## HISTORIC AND DESIGN REVIEW COMMISSION

### Agenda Item No: 14

**HDRC CASE NO:** 2016-211  
**ADDRESS:** 529 MASON ST  
**LEGAL DESCRIPTION:** NCB 1263 BLK 2 LOT 15  
**ZONING:** R6 H  
**CITY COUNCIL DIST.:** 2  
**DISTRICT:** Government Hill Historic District  
**APPLICANT:** Cristina Noriega  
**OWNER:** Cristina Noriega  
**TYPE OF WORK:** Porch column replacement  
**REQUEST:**

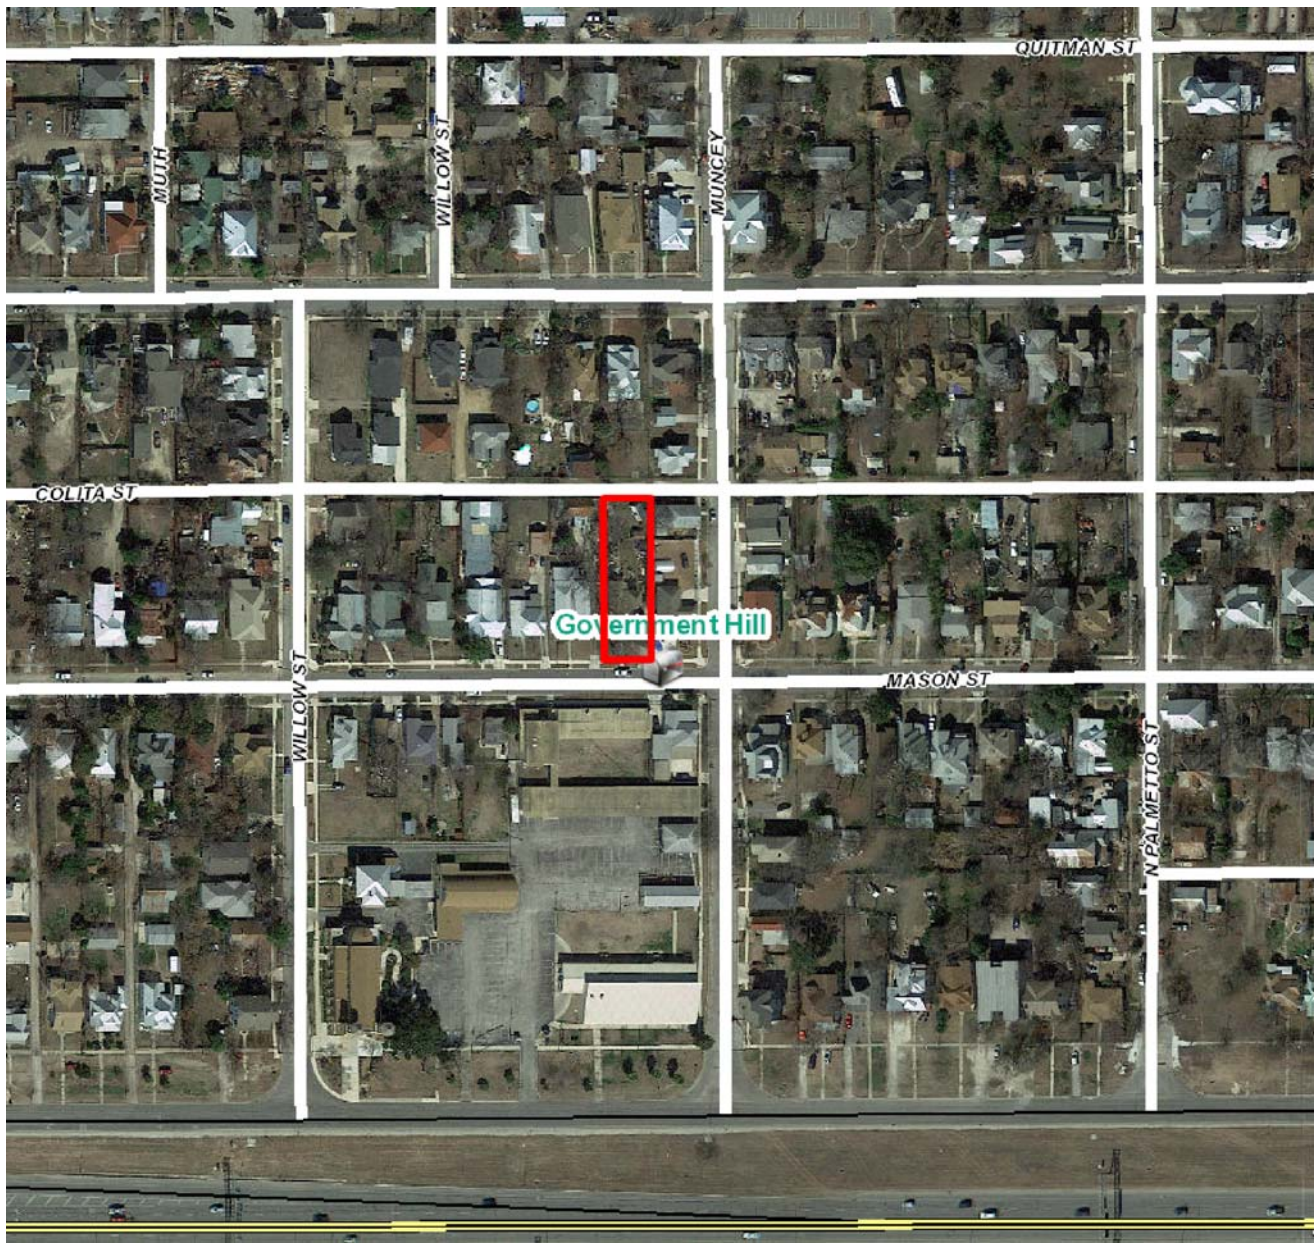
- a. The structure at 529 Mason was constructed circa 1910 and features elements of the Folk Victorian style, most prominently the front gable and wing. The applicant has proposed to remove the five existing, non-original wrought iron front porch columns and replace them with four circular, fiberglass columns. An additional half column will be located at the location where the porch meets the front façade of the primary historic structure.

- b. According to the Guidelines for Exterior Maintenance and Alterations, replacement elements of porches, such as columns, should be compatible in scale, massing, detail and materials as the original elements of the structure. The applicant has proposed circular, fiberglass replacements columns, which architecturally are not appropriate for a Folk Victorian style house. Folk Victorian style houses commonly feature square columns with little to no ornate detailing. Staff finds the applicant's proposal of circular, fiberglass columns inappropriate in design and materials. Staff recommends the applicant propose square, wood columns similar to examples provided by staff.

Staff recommends approval of the applicant's modified proposal of square columns with the stipulation that the applicant add chamfered corners.
